ZONING CHANGE REVIEW SHEET

CASE: C814-2017-0001 – 425 W. Riverside PUD

ADDRESS: 425 W. Riverside Drive

ZONING FROM: CS-1-V-NP **TO:** PUD-NP

EXHIBIT - TREE PLANTING DETAILS

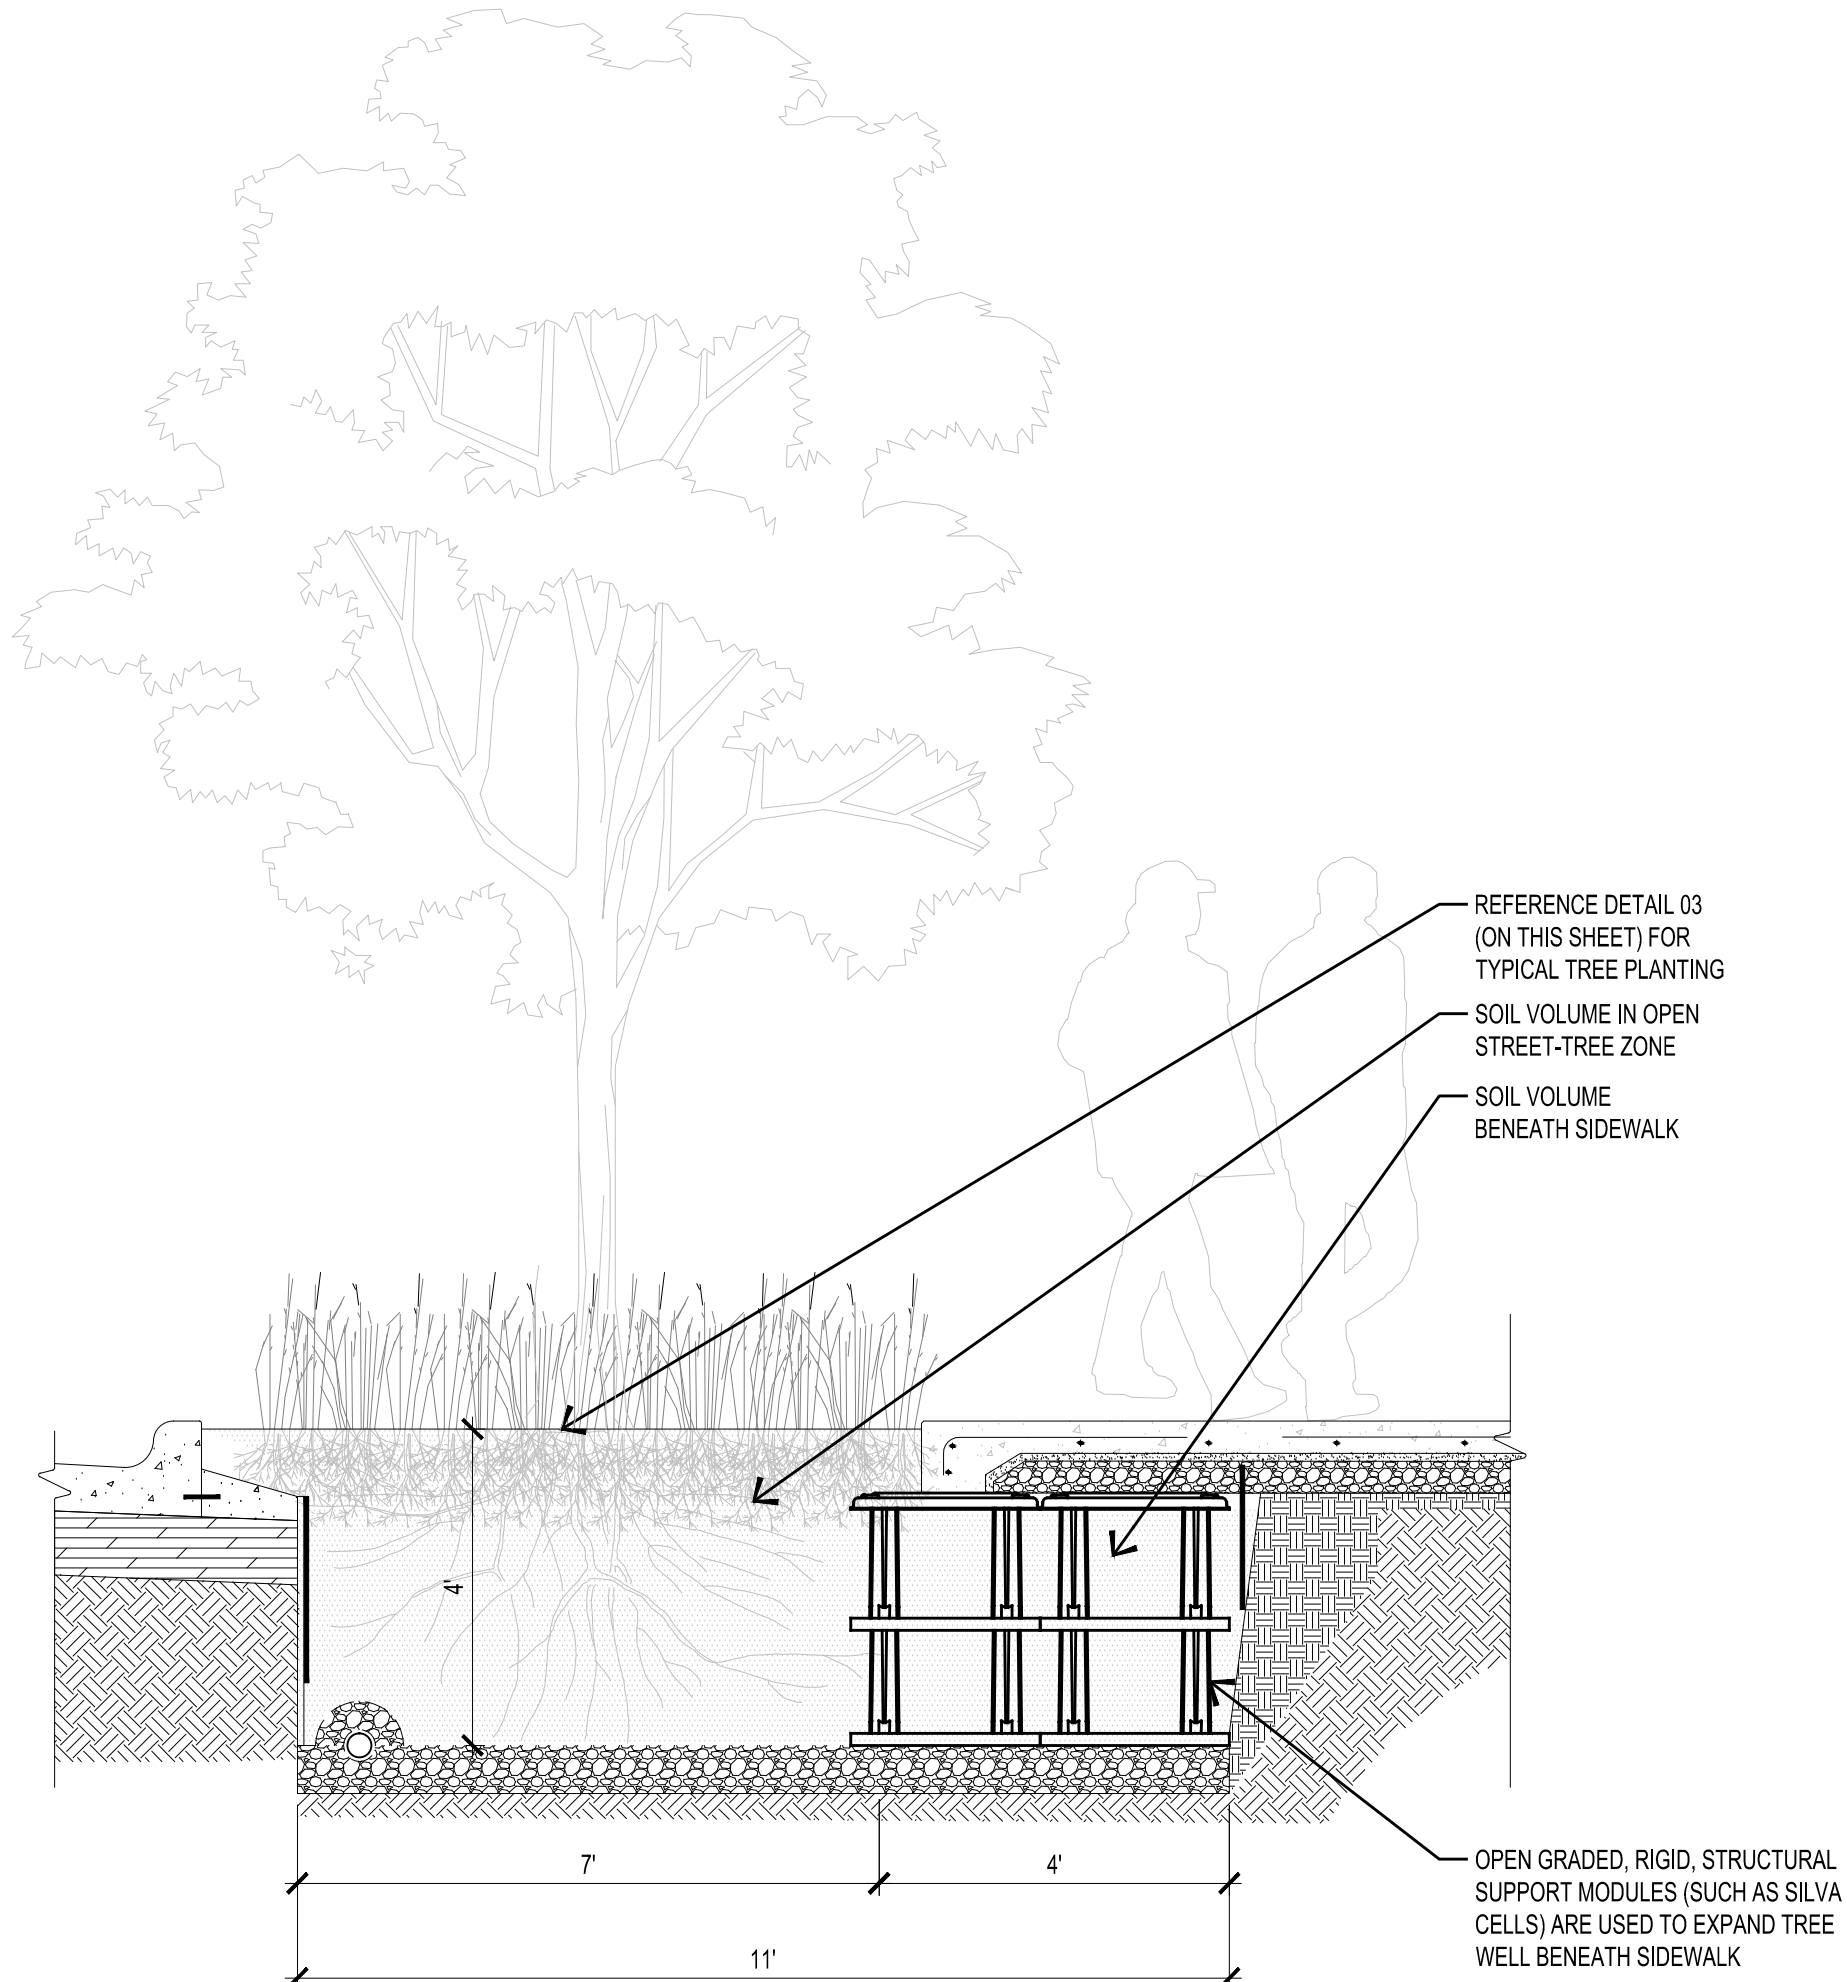
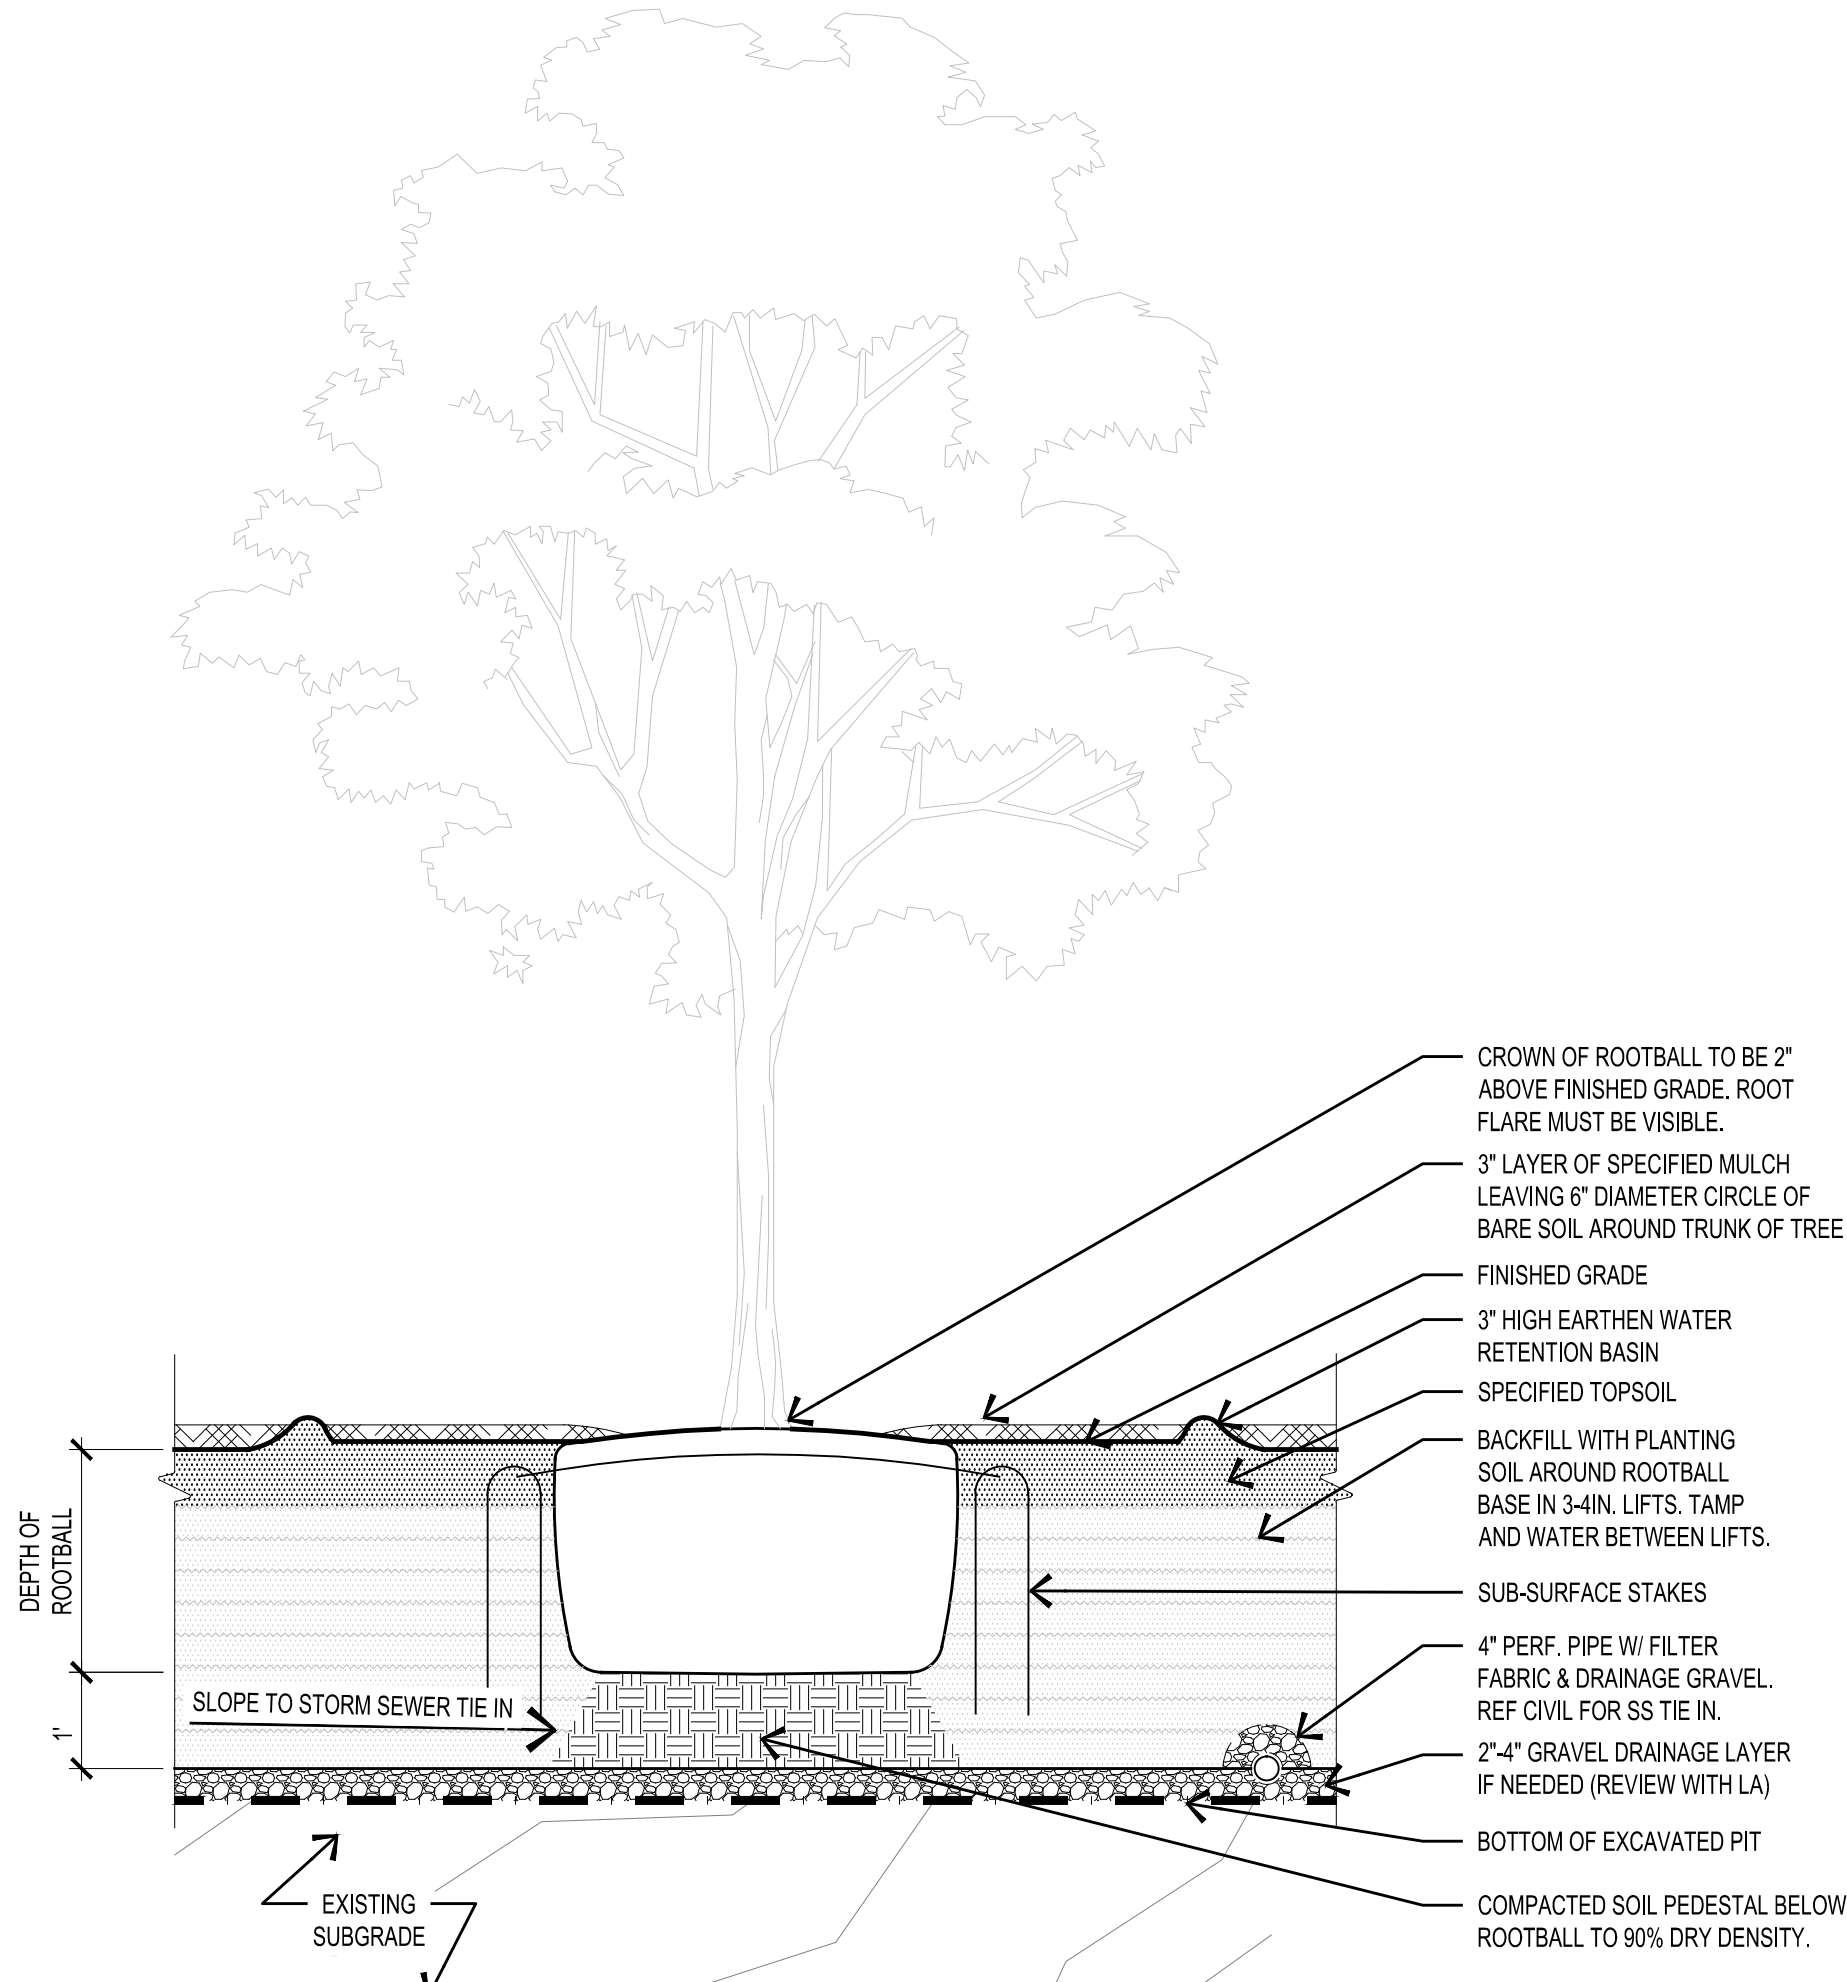
UPDATE 1: Please show how at the proposed spacing between street trees the PUD can achieve 1,500 Cu.Ft per tree. See HT 1 response. The proposed rain garden areas would not seem to be able to meet this area requirement if they were walled confined spaces. Please clarify if the planting zone is truly 8 feet or if it will really be 7.5 feet or less to account for the curb or any type of moisture barrier between the zone and back of curb. Comment pending.

UPDATE 2: Staff is still unclear how the overall inches to be planted number was derived as I only received one of the two exhibits mentioned in your response. Please provide at our next meeting for review. Soil volume will also be discussed and the commitments and exhibits needed for the final PUD document. Comment pending.

UPDATE 3: Thank you for the additional information and calculations. While the PUD proposed planting of a larger diameter street tree could be considered for some environmental superiority, it would normally be a proposal to plant more trees than what would be required that would carry more weight. The PUD proposes a starting overall total frontage a bit less than the current code scenario. It also proposes an additional loss of frontage to accommodate greater options for alternative transportation with two new bus stops. These additional losses in total only allow the PUD scenario to plant one additional tree than the current code option. In this case, it will be the guarantee to plant a shade tree of higher quality that will carry some environmental superiority. To this point, because a multiplier has been used in both calculations to estimate loss due to utility conflicts and not on the ground verification staff is still not able to support the overall tree planting estimates.

Please also revise your soil commitments and notes to be consistent with the last update. These should include the larger 1540 CY soil volume required in locations other than ones with utility conflicts. In those cases where it is proven utility conflict then 1000 CY minimum is accepted with the use of soil cells. Comment pending.

UPDATE 3: Using the ANSI planting standards is acceptable but not superior, as these would be done anyway. Please explore additional standards for tree quality, to assure the best possible tree stock is available for the PUD. These could include presence of visible root flare a time of planting and no girdling roots. Comment pending.
